Access Compliance Report

Public Rights-of-Way

(Pedestrian Signals)

Intersection ID: N/A	Main Street:	Cross Street: N/A	Location: N/A
ADA ID: 7B42E98A2877	Signal Type: One Push Button-APS	Overall Compliance: No	Severity Score: BTN 1: N/A BTN 2: N/A No BTN: N/A
Codes/Mitigation Info/Possible Solution		Field Measurements/Component Compliance

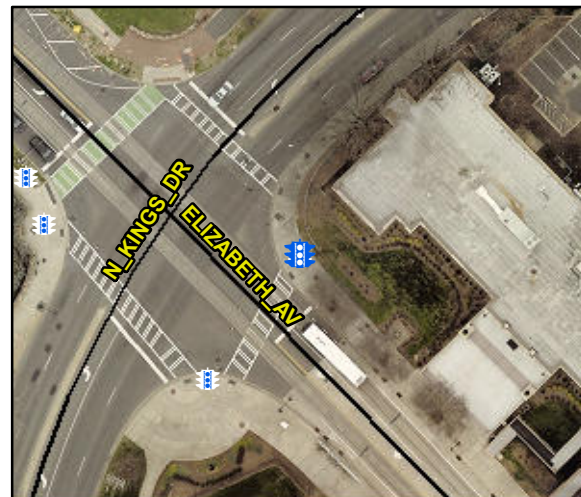
Yes	B 1 Clear Xing Direction?	ClearlyMarked	N/A	B 2 Clear Xing Direction?	N/A
	B 1 Crossing Direction	To SW		B 2 Crossing Direction	N/A
Yes	B 1 DistanceTo XWalk (in)	0.0	N/A	B 2 DistanceTo XWalk (in)	N/A
No	B 1 DistanceTo Curb (in)	131.0	N/A	B 2 DistanceTo Curb (in)	N/A
Yes	B 1 Diameter (in)	2.0	N/A	B 2 Diameter (in)	N/A

Possible Solutions: Replace Signal Push Button With APS Button on New Post. Remove & Relocate Sign.
